VILLAGE REVIEW BOARD

VILLAGE REVIEW BOARD AGENDA TUESDAY, AUGUST 4TH, 2020 7:15 P.M.

DRAFT FINDINGS OF FACT REQUEST FOR CERTIFICATE OF APPROPRIATENESS VILLAGE REVIEW BOARD

DRAFT FINDINGS OF FACT REQUEST FOR CERTIFICATE OF APPROPRIATENESS FOR NEW CONSTRUCTION AND ALTERATIONS TO AN EXISTING STRUCTURE VILLAGE REVIEW BOARD

5 DUNNING St.

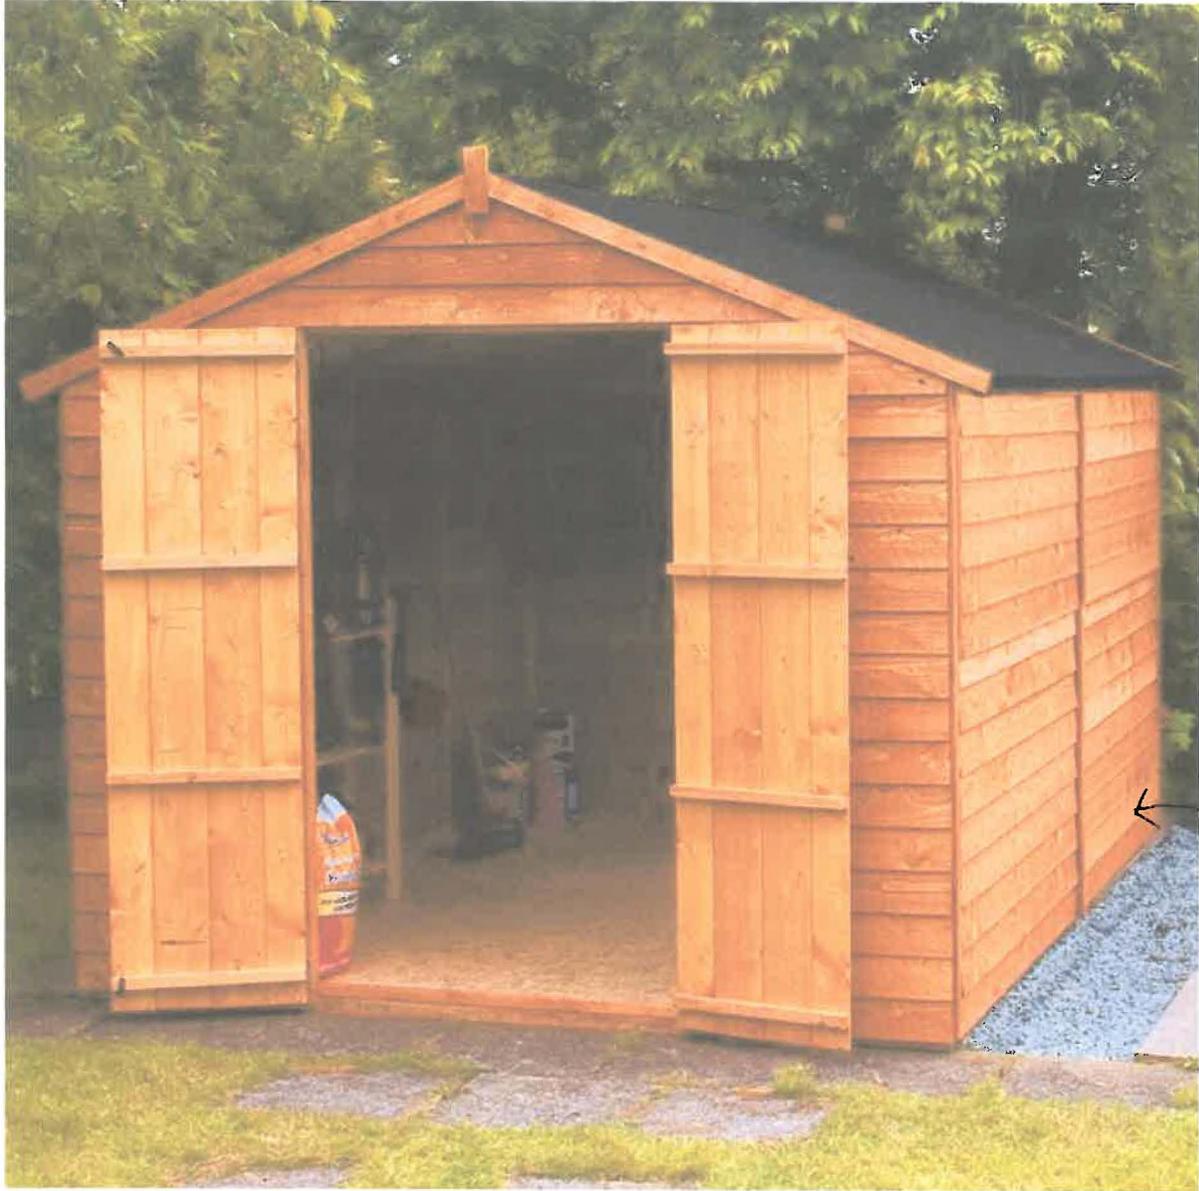
Shed must be 3 feet from side
property lines and 10 feet from gate.
Impervious surface (driveway) close to max-
shed replacement okay
